Detailed Site Plan Magruder Pointe

DSP-18005

STAFF REPORT

SUBJECT: Detailed Site Plan DSP-18005
Magruder Pointe

Exhibit 1. Lots 20 & 22, Shared Area Dedicated to HOA

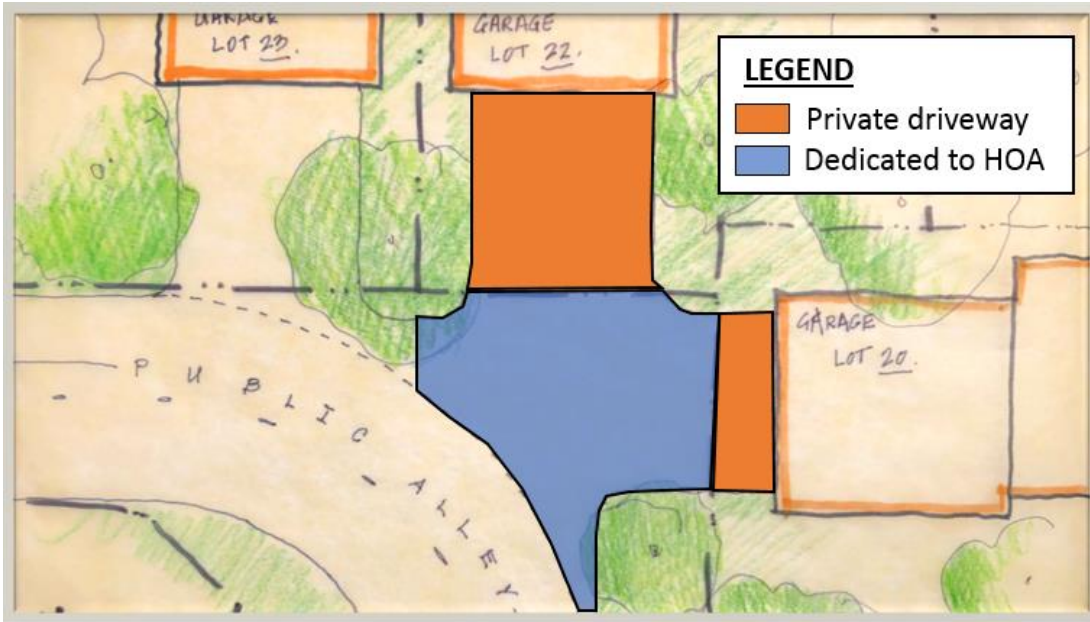
- e. Include a structured pathway on the west side of the site to give individuals a direct pathway from Hamilton Street to Magruder Park.
 - f. Revise the site plan to show that all lots shall have a separate dedicated driveway apron, as shown in the City of Hyattsville's Exhibit 2.
